**Docket Item #9**  
**Special Use Permit #2022-00028**  
**1940 Duke Street**  
**Carlyle Block C Rooftop Amendment**

<p><b>Purpose of Application</b></p> <p>Consideration of a request for a Special Use Permit to increase the gross square footage allowable for Carlyle Block C within the allowed maximum for the Carlyle District and to amend the Design Guidelines for Block C, which includes an increase in height from the maximum of 82' currently allowed to 96'.</p>
<p><b>Staff Recommendation:</b> APPROVAL <u>WITH CONDITIONS</u></p>
<p><b>Staff Reviewers:</b>            Robert Kerns, AICP; Development Division Chief, P&amp;Z <a href="mailto:robert.kerns@alexandriava.gov">robert.kerns@alexandriava.gov</a>            Anna Franco, Urban Planner III, P&amp;Z <a href="mailto:anna.franco@alexandriava.gov">anna.franco@alexandriava.gov</a></p>

**Special Use Permit #2022-00028**  
**1940 Duke Street -**  
**Carlyle Block C Rooftop Amendment**

*Figure 2: Proposed Architecture*

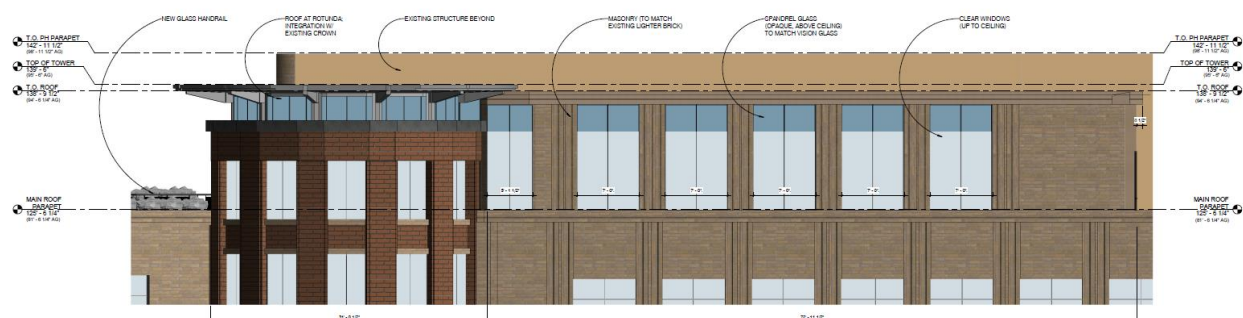
1. **Maintain Disengagement of Tower:** Maintaining the existing turret form, materials and visual separation was the highest priority of the DRB. The turret is a landmark architectural form with views from many surrounding areas of the City. It was also noted that DRB members did not feel the City's and Applicant's goals are necessarily in conflict regarding the tower; it is more about making some strategic design adjustments. Based on the revised plan, Board members agreed that keeping one additional column adjacent to the north roof terrace would create a stronger sense of the cylindrical form and should be studied.

3. **Vision glass in upper tower openings:** Depending on confirmation of additional details with the turret construction, the DRB's strong preference was for clear vision glass in the openings of the turret. Applicant's revised material shows this in some views, but spandrel glass in others, and continues not to show the significant, circumferential beam which connects the crown brackets. This in turn leaves the DRB with questions about the extent of demolition that is being proposed.

**Condition 70B,a:** To ensure the disengagement of the tower along Duke Street, make the changes to the enclosure connection and deepen the notch between the existing tower and the proposed board room as shown on Attachment #7 and in Figure 3 below. (P&Z)

# 04 | BUILDING ELEVATION AT ROOF

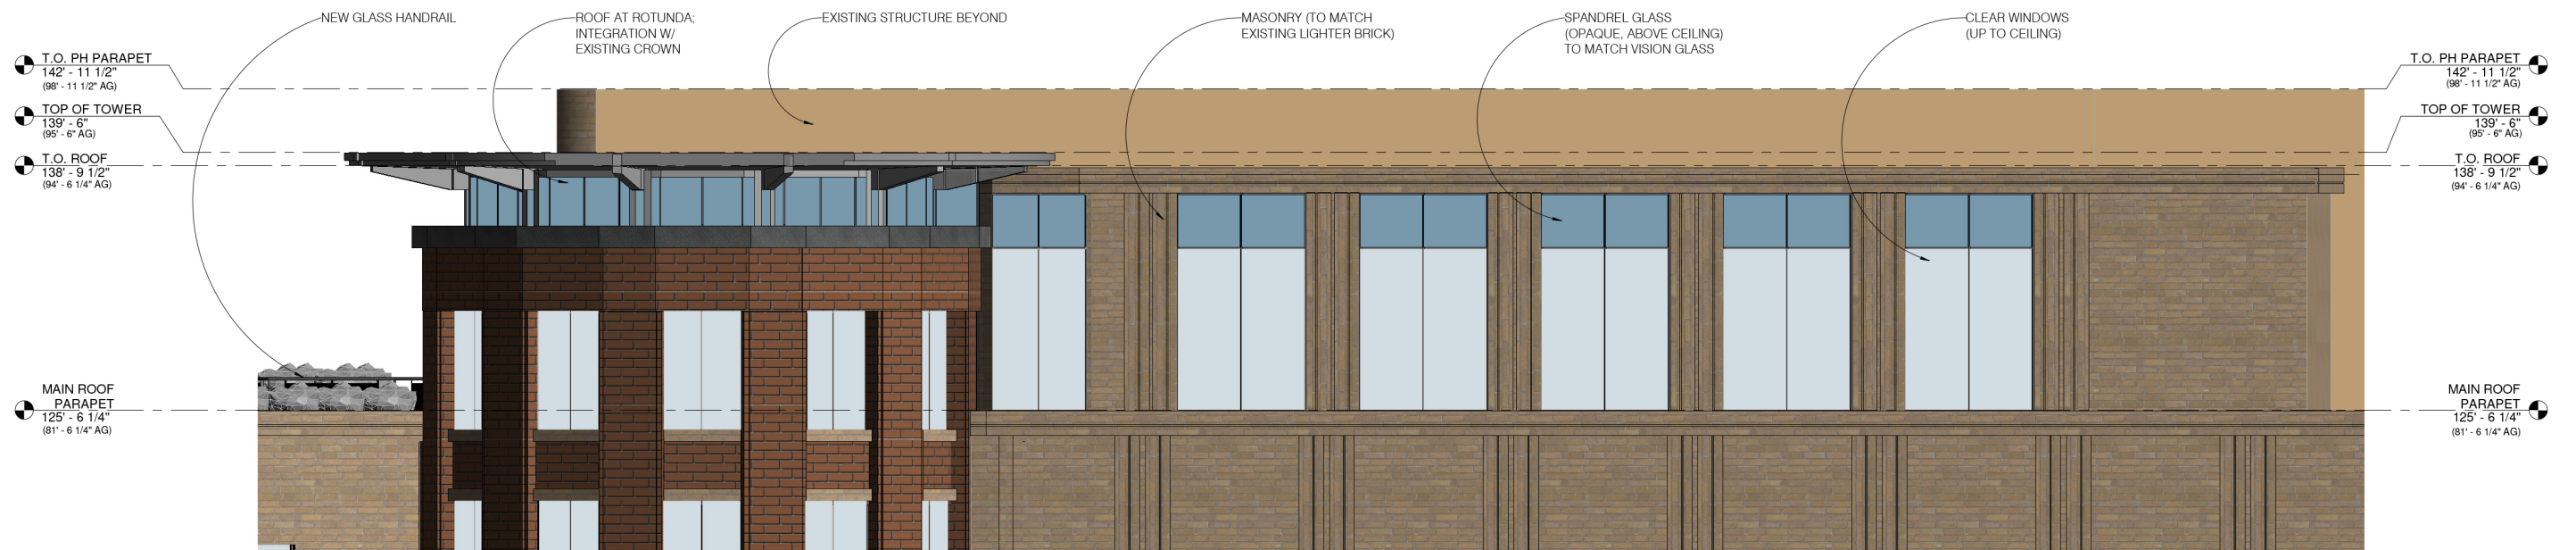
BUILDING ELEVATION - DUKE ST.  
REVISED - PER DRB COMMENTS 7/21

BUILDING ELEVATION - DULANY ST.  
REVISED - PER DRB COMMENTS 7/21
